Access Compliance Report

Public Rights-of-Way

(Curb Ramps)

Intersection ID: 42493	Main Street: REA_RD	Cross Street: TOLLESON_AV	Location: NW
ADA ID: 2D3B217BEF5B	Ramp Type: Perp	Initial Pass/Fail: Fail	Overall Compliance: No
Severity Score: 21.25			
Codes/Mitigation Info/Possible Solution		Field Measurements/Component Compliance

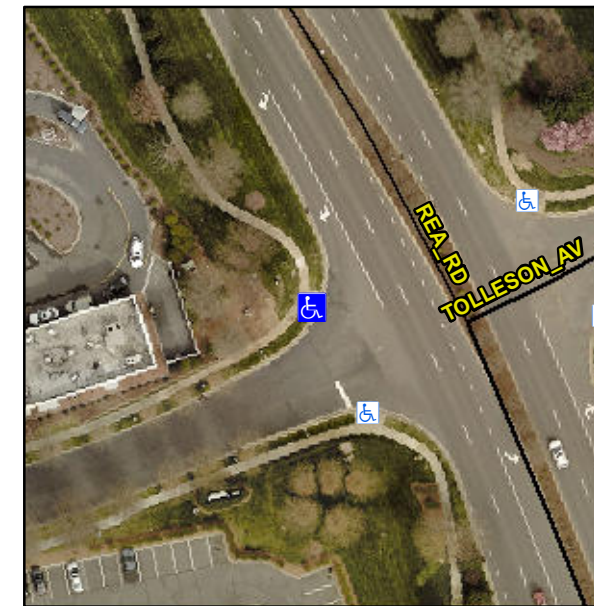
R304.5.1, R304.2.2

Compliance	Description	Data	Compliance	Description	Data
N/A	Ramp Length (in)	70.0	No	Ramp Slope (%)	11.1
No	Ramp Width (in)	40.0	Yes	Ramp XSlope (%)	0.8
N/A	Flare Type LT	N/A	N/A	Flare Type RT	N/A
N/A	Flare Slope LT (%)	N/A	N/A	Flare Slope RT (%)	N/A
N/A	Flare Traversable LT?	N/A	N/A	Flare Traversable RT?	N/A
N/A	Landing Length (in)	N/A	N/A	DWS Provided?	N/A
N/A	Landing Width (in)	N/A	N/A	DWS Contrast?	N/A
N/A	Landing Slope (%)	N/A	N/A	DWS Length (in)	N/A
N/A	Landing X Slope (%)	N/A	N/A	DWS Full Width?	N/A
N/A	Landing Curb? (Y/N)	N/A	N/A	DWS Offset (in)	N/A
N/A	Shared Landing?	N/A			
N/A	Gutter Ponding?	N/A	N/A	Gutter Slope (%)	N/A
N/A	Gutter Lip Ht (in)	N/A	N/A	Gutter X Slope (%)	N/A
N/A	Painted X Walk1?	No	N/A	Painted X Walk2?	N/A
	X Walk 1 Direction	To SE		X Walk 2 Direction	N/A
N/A	X Walk 1 Width (in)	N/A	N/A	X Walk 2 Width (in)	N/A
	X Walk 1 Slope (%)	1.0		X Walk 2 Slope (%)	N/A
	X Walk 1 X Slope (%)	0.7		X Walk 2 X Slope (%)	N/A

Remove & Replace Entire Ramp.
